29 August 2023

## **AELTC application to fell trees on Wimbledon Park Heritage Land 23/T2126**

For the Wimbledon Park Residents' Association, 56 Home Park Road, SW19 7HN.

**Figure. Part of the proposals map with annotations A and B added.**

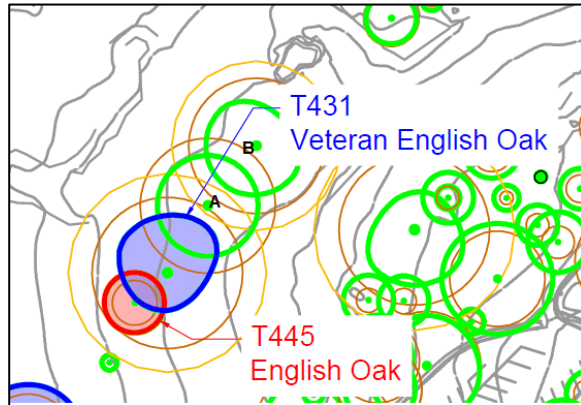
Some advocate clearing away younger trees nearby old specimens, in the belief that this reduces competition for light and for access to soil moisture and nutrients. However, there are no good studies demonstrating any benefit, or harm, from such “haloing”<sup>v</sup>. 16 Trees are proposed to be removed, mainly to protect old English Oaks from harm (English Oak T445, Red Oak T155, Turkey Oaks T157 & T287, Bird Cherry T289, Lime T310, Hybrid Poplar T465, Silver Birch T482 & T622, False Acacia T505, Sweet Gum T518, Sycamore saplings T545, Ash T579, Leyland Cypress Hedge C1, Norway Maple E2, Western Red Cedar WRC2). T287 and T289 are close to the veteran Tudor Oak (T288) and so are justifiable removals, if replacement planting should prove possible<sup>vi</sup>. No such need is evident for the other 14 proposed removals, as is illustrated by English Oak T445, which is said to be a “young tree suppressing the growth of branches on the west side of Veteran English Oak T431” (see the Figure).

The Figure shows that the veteran (in blue) is, in fact, equally “threatened” by another old tree “A”, which in turn is “threatened” by veteran “B”. Tree “A” clearly overlaps more than any of the other four, but is not proposed for removal. In fact, there is no significant threat to any of these four English Oaks from its neighbours, because the overlap is small. So, the healthy English Oak, T445, does not need to be removed. Similar analysis shows no need to remove any of the other 13 trees. Again, any removals would require replacement planting, and none is proposed.
